Board of Zoning and Planning Staff Report September 26, 2024

Matt Klingler, Zoning Officer

- 1) Application Number: BZAP-24-19
Address: 261 N Stanwood
Applicant: Brenda Parker
Owner:

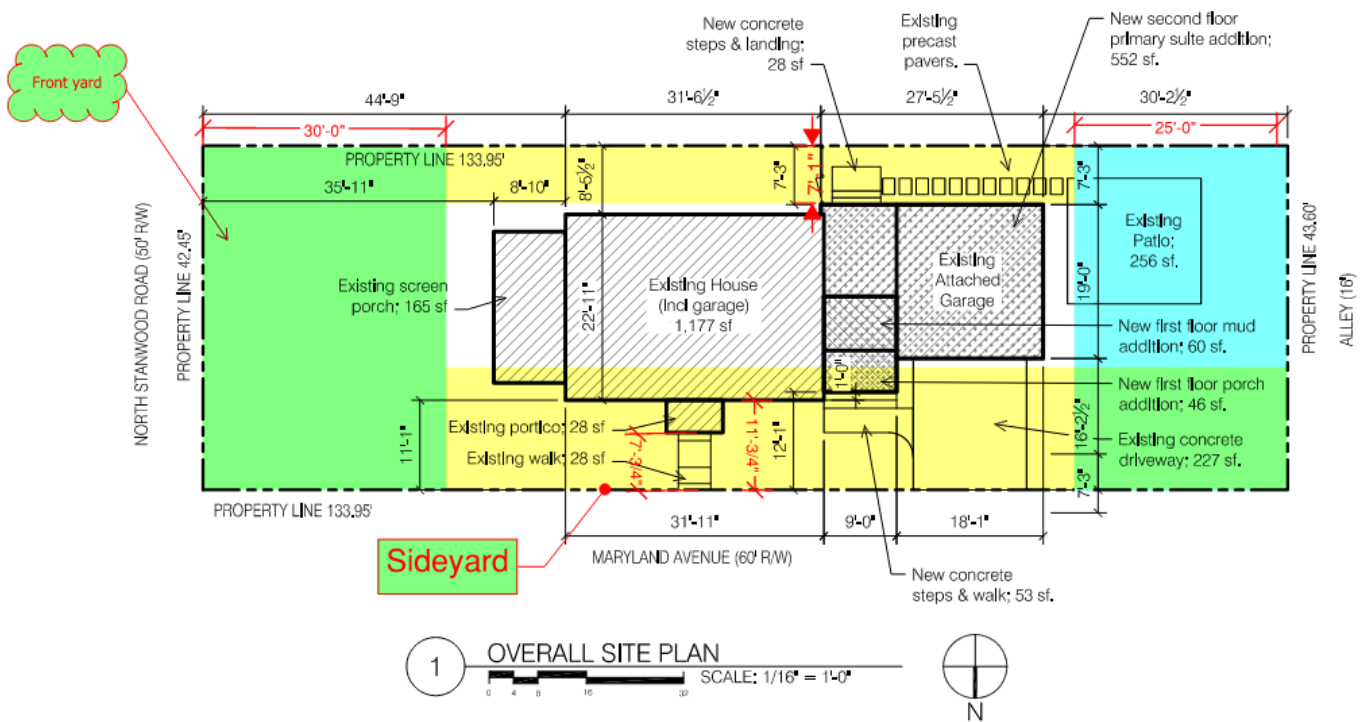
- The existing house has a portico that sits 7' -3/4 from the property line.
- The current house sits 11' 1" from the side yard property line.
- The new addition will sit 12'-1" from the property 1 ft farther back than the existing house.
- Staff sees no issue with this variance.

- 2) Application Number: BZAP-24-26
 Address: 662 Vernon
 Applicant: Ryan Brothers' Landscaping -Pat Ryan
 Owner: Dale Rucker

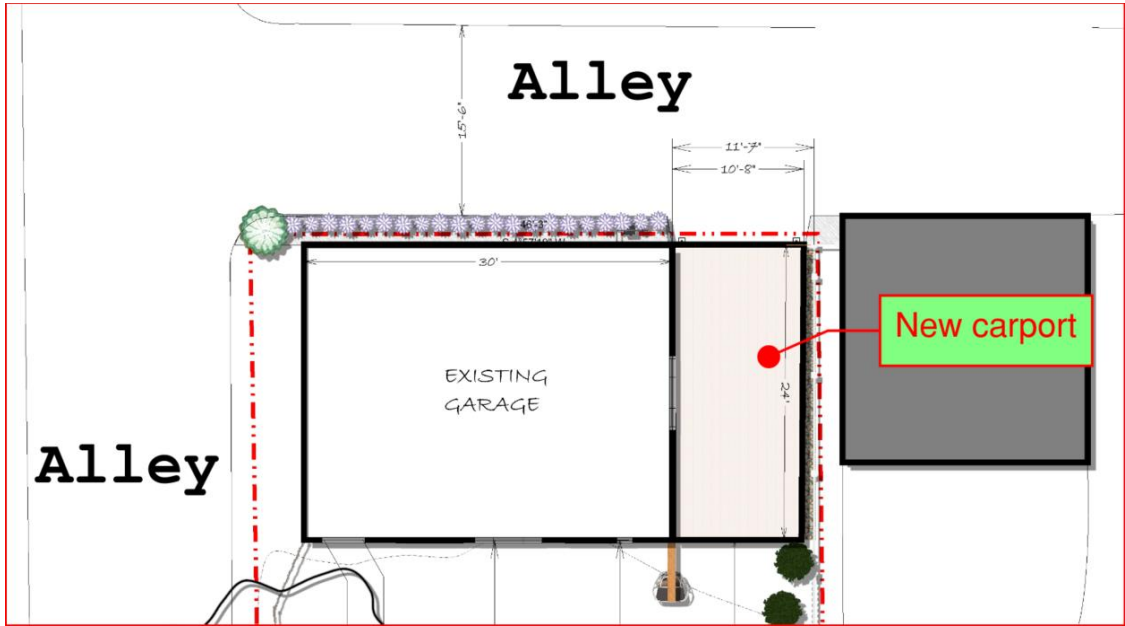
- The current garage (692 sq. ft.) does not conform to code requirement of accessory structure's footprint to be less than 624 sq. ft.
- The maximum width of 60% for accessory structures is there for Emergency personnel to be able to access in case of Emergency.
 - This addition will present a safety issue for rear yard access.
- Also, the requirements of 3 ft off property lines is for safe access in the event of an emergency.
- If the variances are granted, the Architectural review board asked that the project be sent back to them for review and final design approval.

-
- 4) Application Number: BZAP-24-30
 Address: 249 S Cassingham
 Applicant: Brenda Parker
 Owner: Steve Lieb

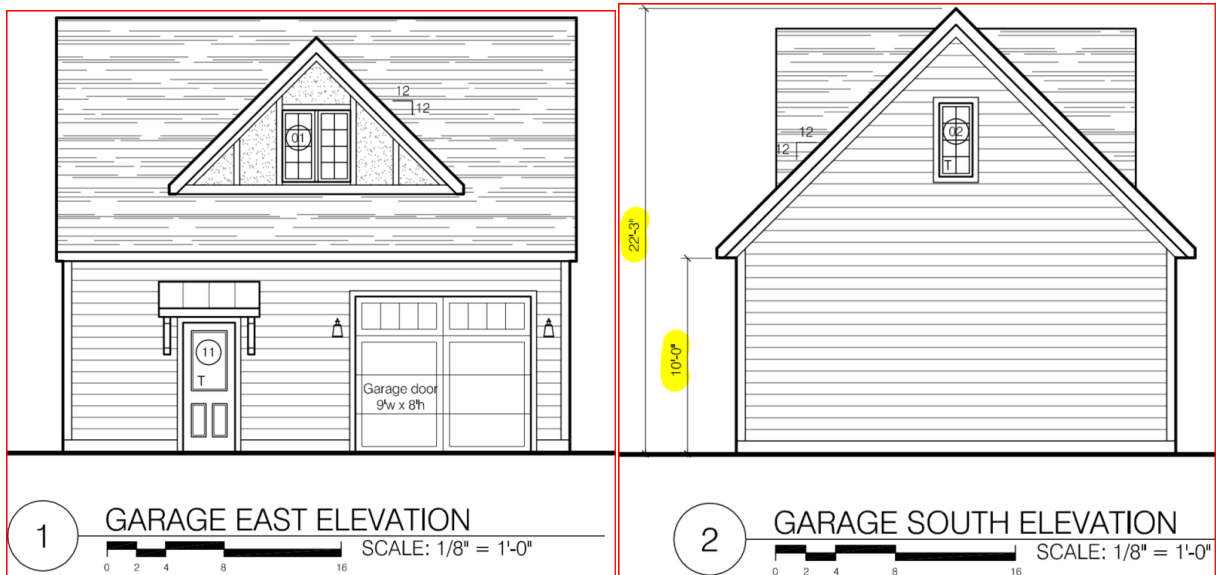
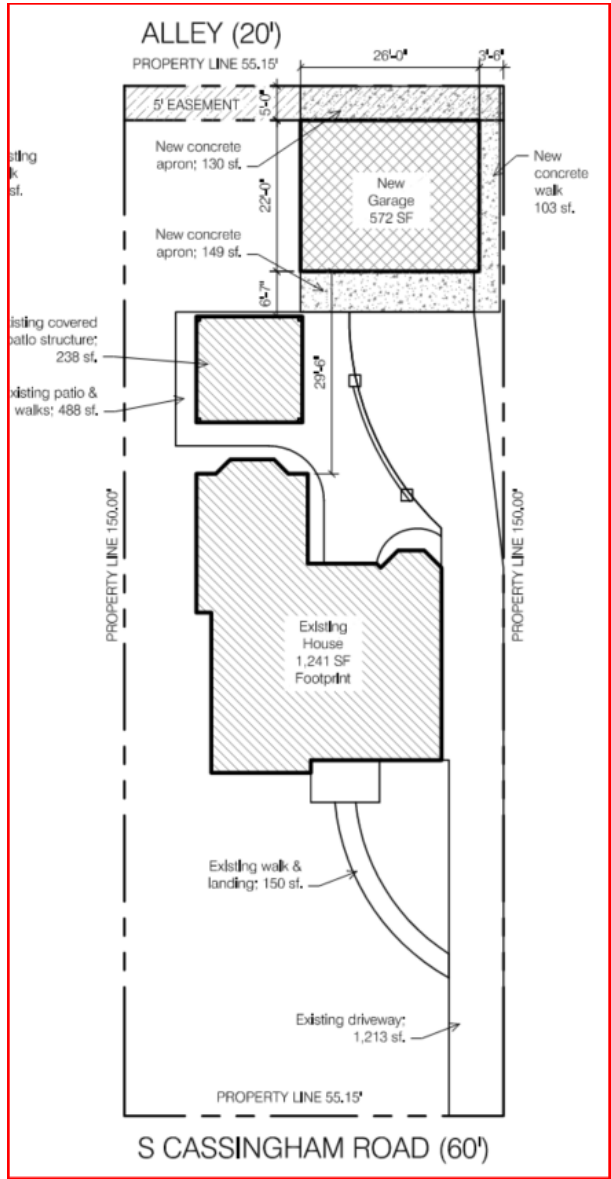
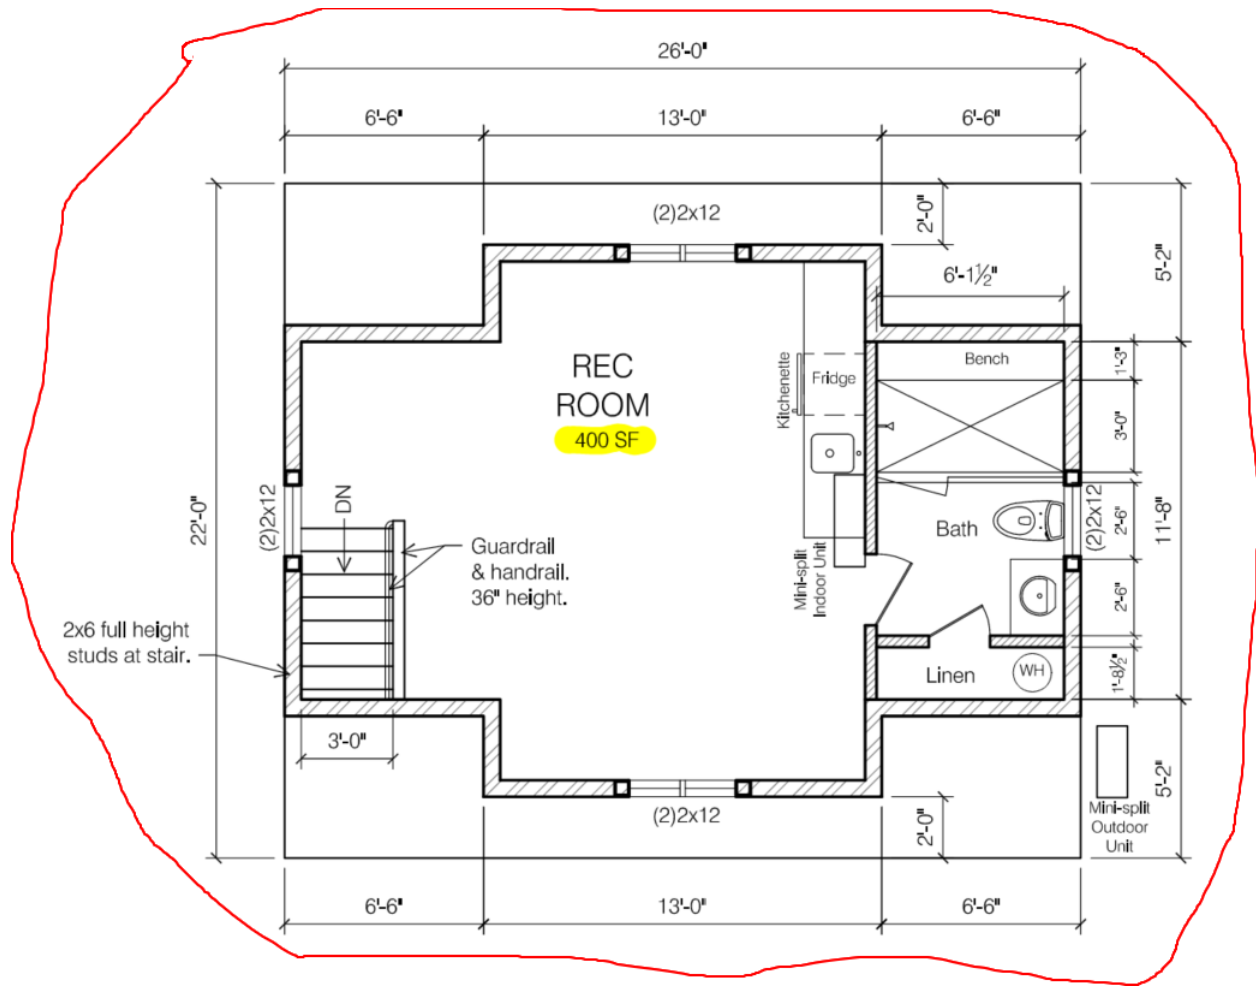
- The Architectural Review voted to send this BZAP without a recommendation either for or against the application, with the request that if the variances are granted that it be remanded back to the ARB for final design review and certificate of appropriateness.
- What the applicant is proposing is a large height variance for this size property. It is out of character with the other garages on this alley. There are no other garages on this alley that are 2 stories.

5) Application Number: BZAP-24- 32
 Address: 2460 Seneca Park Place
 Applicant: Aron Rogers
 Owner: Aron Rogers

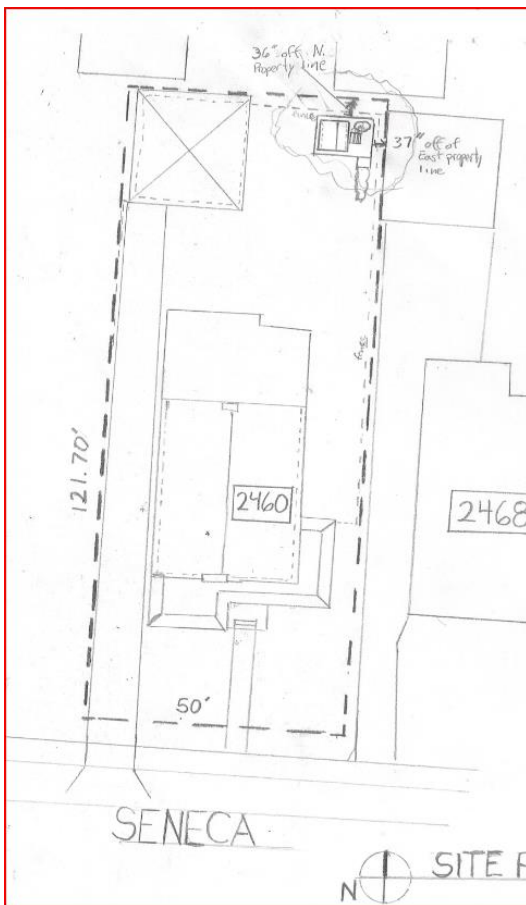
- Applicant has begun building a tree play house for his children.
- The tree/ play house leans up against/ is attach to and surrounds a large silver maple on at the Northeast corner of the property where the 2 property fences (rear & east) adjoin.
- Applicant has tried to locate the iron pins, but could not find them in the rear o f the property only the front of the property.
- A site survey (iron pin or mortgage) has not been submitted which we do not require but in this case the staff has nothing to verify the property lines other than the fences and Franklin County Auditor site.
 - We typically tell residents to not use the Auditor site because it is not exact and done many times by fly overs.
